14. DESCRIPTION OF AMENDMENT/MODIFICATION (Organized by UCF section headings, including solicitation/contract subject matter where feasible.) COLLABORATIVE SUPPORT FACILITY, BUILDING N232 AT NASA AMES RESEARCH CENTER, MOFFETT FIELD, CALIFORNIA					
The purpose of this modification is to change the statement of work of the contract. See Page 2 of 2 of this modification.					
Except as provided herein, all terms and conditions of the document referenced in Item 9A or 10A, as heretofore changed, remains unchanged and in full force and effect.					
15A. NAME AND TITLE OF SIGNER (Type or print) JOHN W. ELWOOD VP-DIVISION MANAGER		16A. NAME AND TITLE OF CONTRACTING OFFICER (Type or print) Teresa A. Marshall			
15B. CONTRACTOR/OFFEROR 		15C. DATE SIGNED 2/13/10		16B. UNITED STATES OF AMERICA 	
(Signature of Contractor/Offeror)		(Signature of Contracting Officer)		16C. DATE SIGNED 2/24/10	
NSN 7540-01-152-8070 Previous edition unusable		STANDARD FORM 30 (REV. 10-83) Prescribed by GSA FAR (48 CFR) 53.243

BLOCK 14. DESCRIPTION OF MODIFICATION:

SKETCH # 110309RS

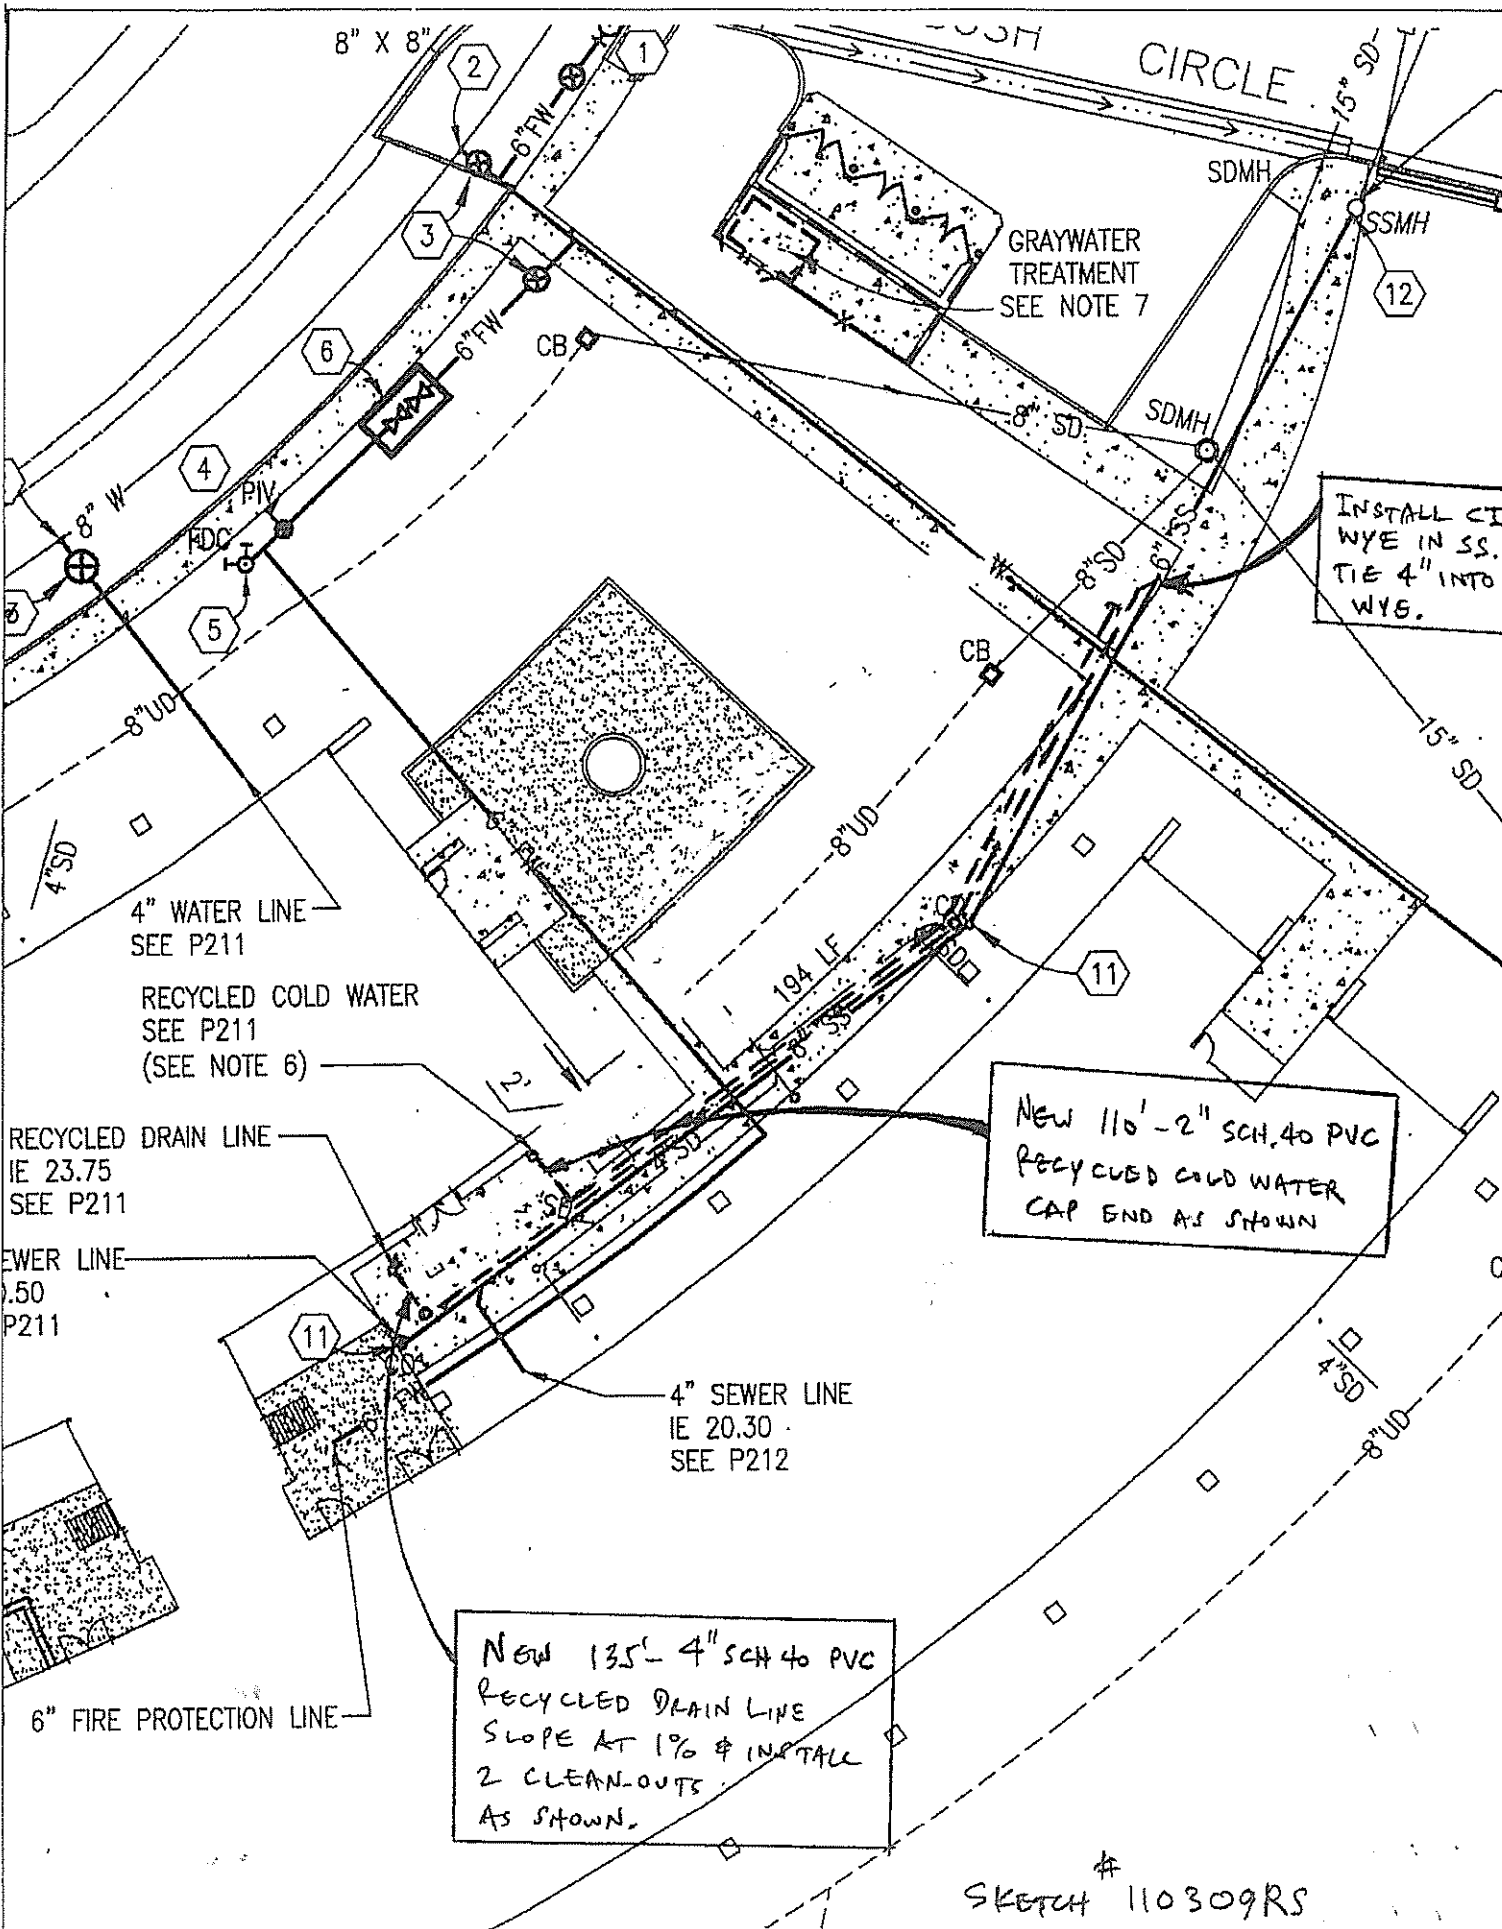
Install approximately 135 feet of 4" schedule 40 PVC Recycled Drain Line and approximately 110 feet of 2" schedule 40 PVC Recycled Water Line.

Terminate new 2" Recycled Water pipe in Room 104. The 2" Recycled Waterline shall transition from PVC to copper pipe underground, before entering Room 104.

Terminate new 4" Recycled Drain by connecting to the 3" Recycle Waste line from the bathrooms.

Route the new 4" Recycled Drain and 2" Recycled Water pipes as shown on Sketch 110309RS. New pipes shall be located north of the existing 6" sanitary sewer, and shall not be installed in the same trench as the 6" sanitary sewer.

Tie the low end of the 4" drain line into the 6" sanitary sewer and cap the end of the 2" recycled water line as shown on attached Sketch 110309RS.

INSTALL CI
WYE IN SS.
TIE 4" INTO
WYS.

NEW 110' - 2" SCH. 40 PVC
RECYCLED COLD WATER
CAP END AS SHOWN

NEW 135' - 4" SCH. 40 PVC
RECYCLED DRAIN LINE
SLOPE AT 1% & INSTALL
2 CLEAN-OUTS
AS SHOWN.
